ADDENDUM No. 4
Structural Steel Painting Services
M&T Bank Stadium
MSA Project No. 22-038

Date Issued: January 14, 2022

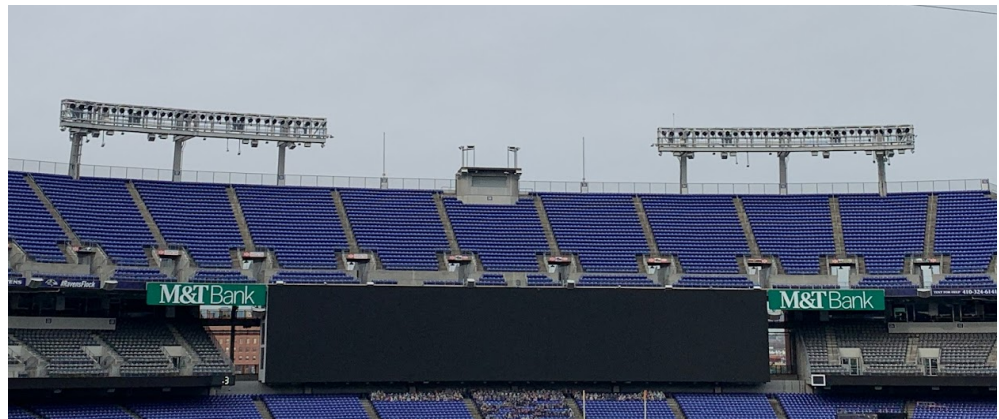
1. For the upper deck above the horizontal beam steel, does the part that extends above the seating bowl need to be painted?

Yes. An example of the steel in question is in the picture below on either side of the coach's booth. These extend up from the raker beams at each location there is not a light tower.
